UNITED STATES
DEPARTMENT OF THE INTERIOR
BUREAU OF LAND MANAGEMENT

FORM APPROVED
OMB NO. 1004-0137
Expires: January 31, 2018**SUNDRY NOTICES AND REPORTS ON WELLS**
Do not use this form for proposals to drill or to re-enter an abandoned well. Use form 3160-3 (APD) for such proposals.5. Lease Serial No.
NMNM94651

OXY USA Inc. respectfully requests the following bulk sundry changes to the approved APD's for the following wells:

OXY USA Inc. – Salt Flat CC 20-29 Federal Com 37H-38H – Amended Drill Plan

General well schematic:

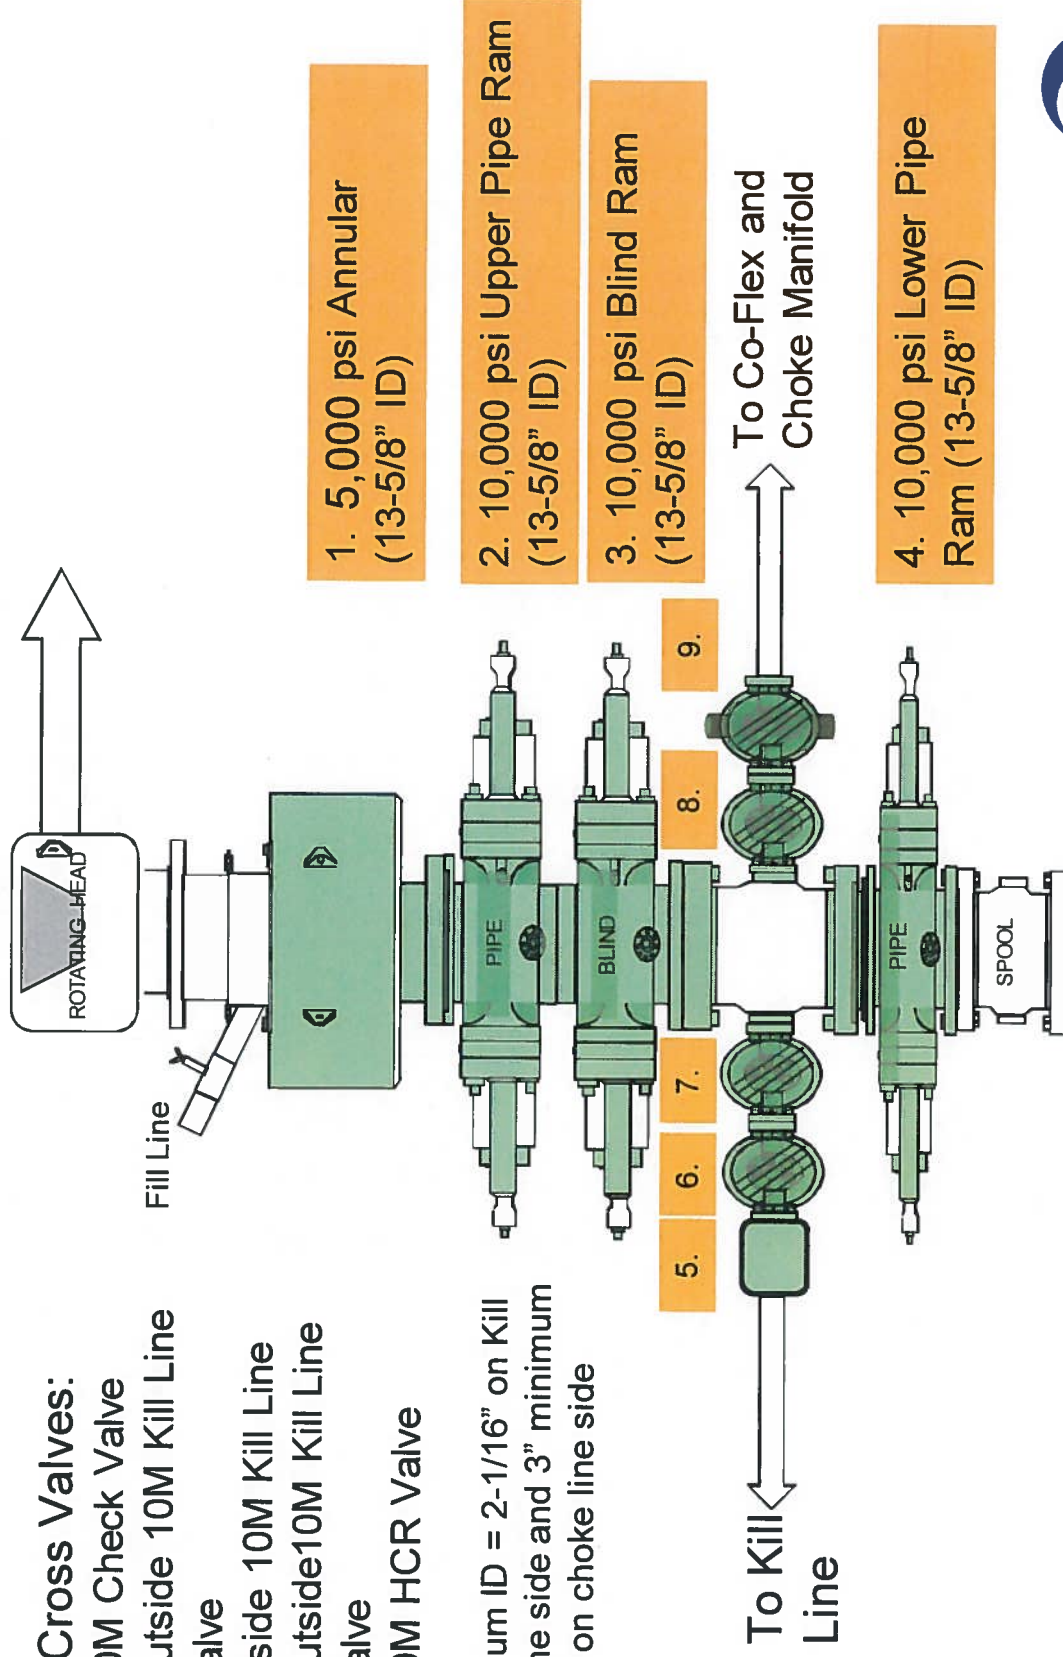
- Drill 17-1/2" hole x 13-3/8" casing for surface section. Cement to surface.
- Drill 9-7/8" hole x 7-5/8" casing for intermediate section. Cement to surface.
- Drill 6-3/4" hole x 5-1/2" liner for production section. Cement to top of liner, 100' inside 7-5/8" shoe.
- Release drilling rig from location.
- Move in workover rig and run a 5-1/2" 20# P110 DQX tie-back frack string and seal assembly (see connection specs below). Tie into liner hanger Polished Bore Receptacle (PBR) with seal assembly.
- Pump hydraulic fracture job.
- Flowback and produce well.

When a decision is made to develop a secondary bench from this wellbore, a workover rig will be moved to location. The workover rig will then retrieve the tie-back frack string and seal assembly before temporarily abandoning the initial lateral.

5/10M BOP Stack

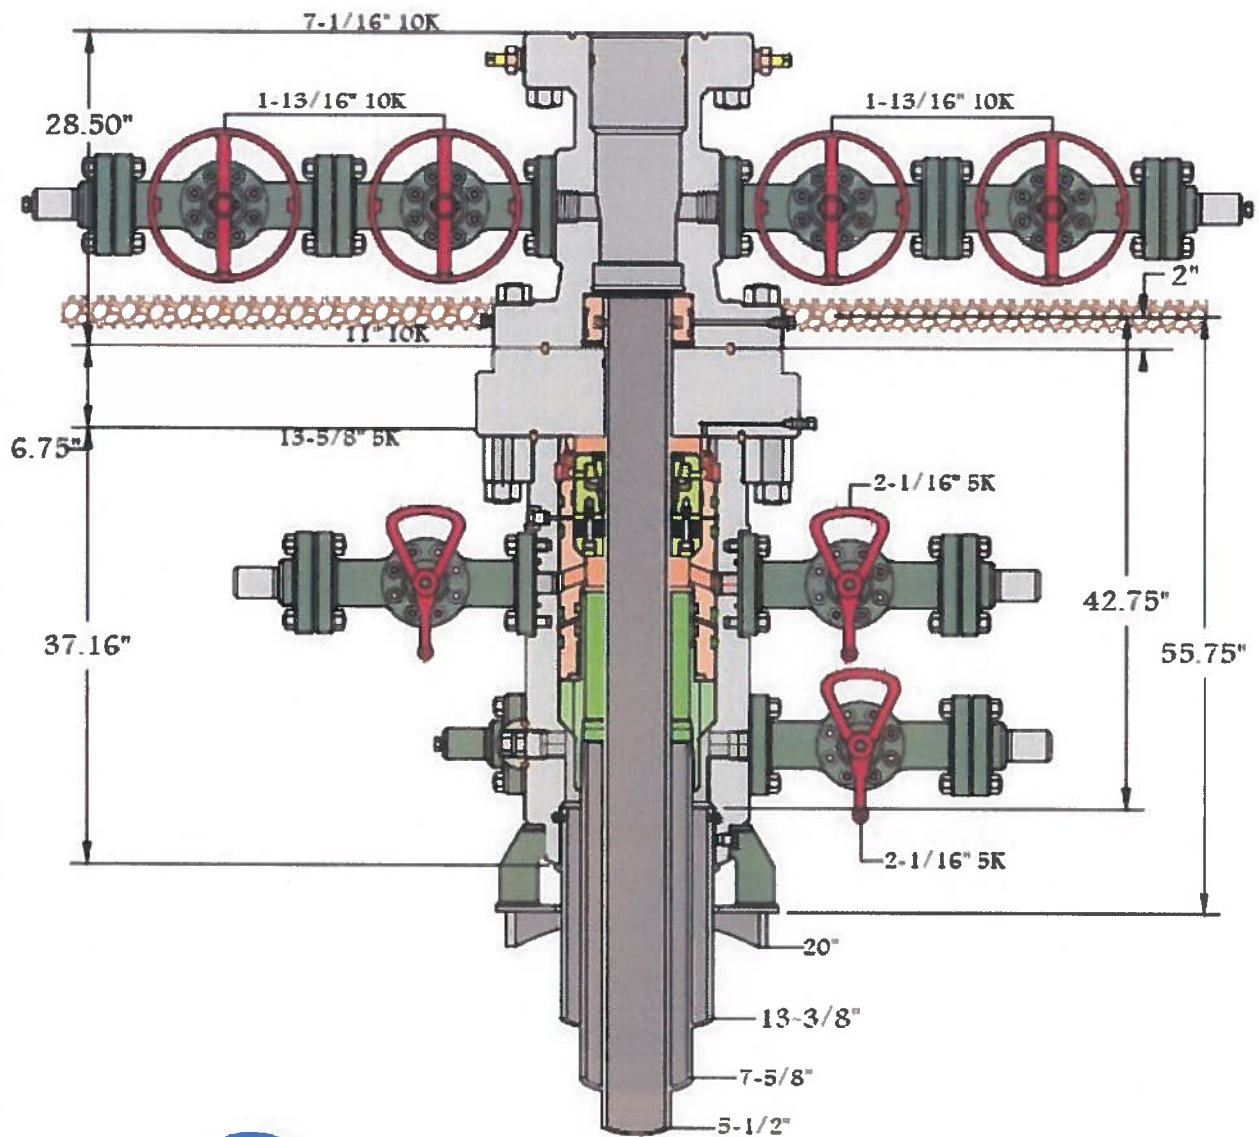
- 2. Request Bradenhead squeeze for the 2nd stage Intermediate casing with the Bradenhead CBL requirement.
- 3. Request Offline Intermediate Casing/Cementing Variance, see attached.
- 4. Update BOP Break Testing Request, Information and Plan
- 5. Update BOP/Wellhead Diagram

Oxy will utilize a 5M annular with a 10M BOPE stack. The BOP/BOPE will be tested by an independent service company to 250 psi low and the high pressure indicated above per Onshore Order 2 requirements. The System may be upgraded to a higher pressure but still tested to the working pressure listed in the table above. If the system is upgraded all the components installed will be functional and tested.
